UNITED STATES PATENT AND TRADEMARK OFFICE

APPLICATION NO.	FILING DATE	FIRST NAMED INVENTOR	ATTORNEY DOCKET NO.	CONFIRMATION NO.
10/628,266	07/29/2003	Arthur Croft	2123-Util	4717

Office Action Summary

DETAILED ACTION
Specification

Fig. 11

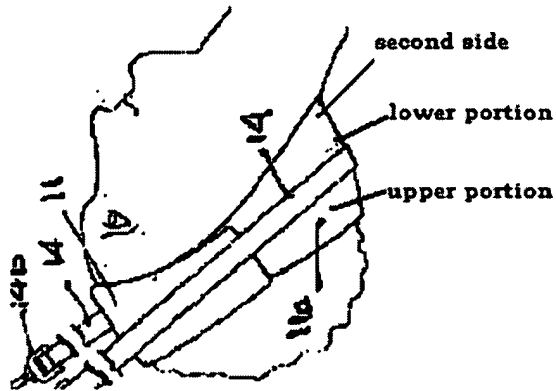
2. As to claims 1-5, and 10, Goodley discloses a self actuated cervical traction device for performing traction on a person's neck comprising, a headpiece (see fig.11, reference object 11a), said headpiece adapted to be secured about the head and further including a first loop (see fig.11, reference object 14), said first loop including a connection anchor (see fig.1, anchor connecting 16 and 18), a cord (see fig.1, reference object 18), said cord affixed to said connection anchor, a force redirection means (see

3. **As to claim 2, Goodley** additionally discloses headpiece includes a first side and a second side, the first loop connected to the second side (see labeled fig.11).

4. **As to claim 3, Goodley** discloses the second side of the headpiece having an upper portion, a lower portion, a right side and a left side, wherein the majority of the first loop is generally attached about the second side of the lower portion (see labeled fig.11).

6. **As to claim 5, Goodley** discloses a strap adapted to be placed about the forehead of a person, said strap has a front side, a back side, a right side and a left side, said strap said back side resides on the forehead of said person (see fig.11, reference object 11).

7. **As to claim 10, Goodley** discloses a traction device to be used by a patient comprising: an adjustable headpiece (see fig.11 reference object 11a), said headpiece attached to the head of the patient, a loop (see fig.11 reference object 14) connected to said headpiece, a cord (see fig.1 reference object 18)
